PLANNING AND ZONING BOARD

CITY OF DELRAY BEACH

---STAFF REPORT---

ITEM: **Metropolitan Plat:** Recommend Certification of the Final Plat associated with the Metropolitan Mixed-Use Development located at the northeast corner of SE 3rd Avenue and SE 1st Street.

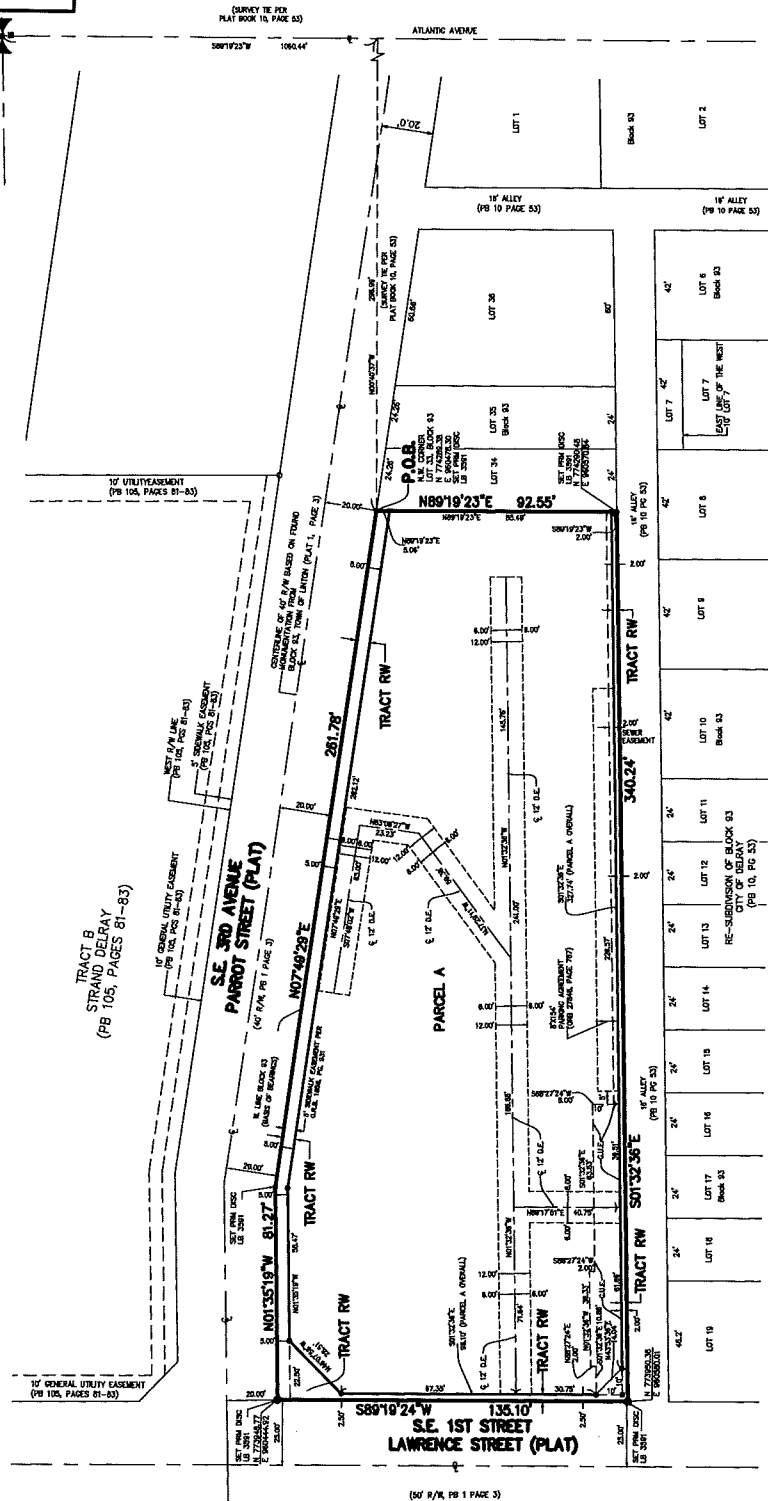
- 1. Prior to certification of the Final Plat by the Planning and Zoning Board and in advance of scheduling for City Commission review and approval, the following must be addressed:
 - a. Provide updated school concurrency letter, valid through 2017.
 - b. Update the square footage calculations on the tabular data chart to reflect consistency on both Sheets 1 and 2 of the Metropolitan Plat.
